Technical Bulletin

New Generation POPIT Missings

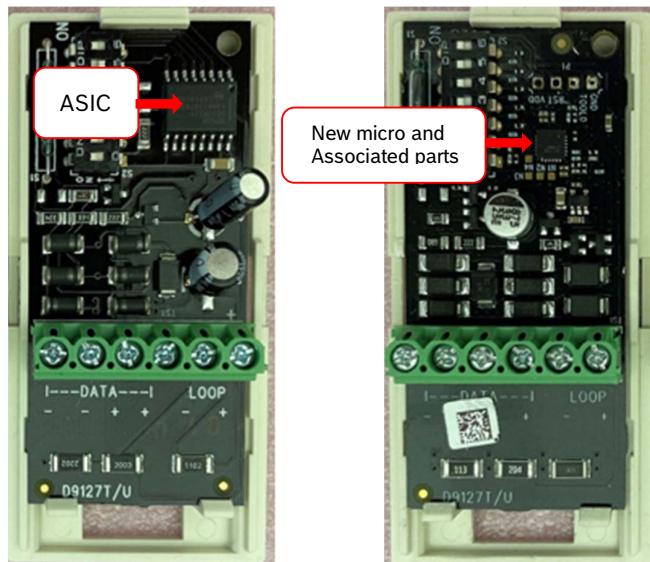
When used on the B9512G or B8512G control panels, any changes made to the panel configuration from RPS, keypad, BMS, etc. may result in new generation POPITs that are connected through a B600/D8125 to show as “missing.” If the change is made while the control panel is armed, the device shown as missing may cause an alarm.

Points shown as missing will return on their own within 30 seconds. Depending on programming, they may need to be cleared or acknowledged.

Bosch will fix this issue in control panel firmware version 3.15.xxx. Expected to release in Q4, 2024.
